**BELL SYSTEM PRACTICES**  
**Teletypewriter and Data Stations**

**ADDENDUM P34.510**  
**Issue 1, January, 1962**  
**AT&TCo Standard**

## **28 DISTRIBUTOR**

### **LUBRICATION**

##### **2.02 28 Distributor—Front**

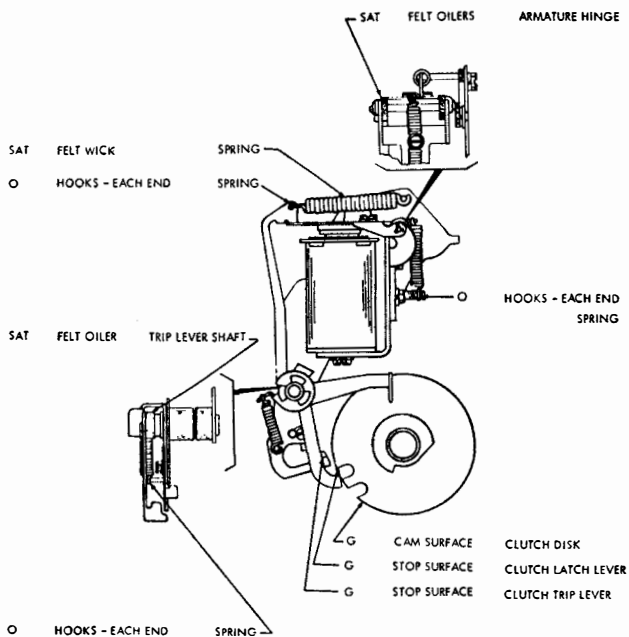
(a) 2.02—added note

**Note:** Where a unit has a cam sleeve assembly with an oil hole, lubricate the felt wick of the main shaft by applying oil through the oil hole. Where a unit has a cam sleeve assembly without an oil hole, remove the main shaft and apply oil to the felt wick.

## 2.08 Contact Lever Assembly

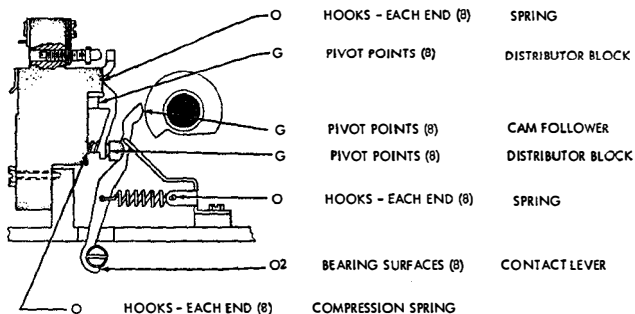
(b) 2.07 through 2.10—added
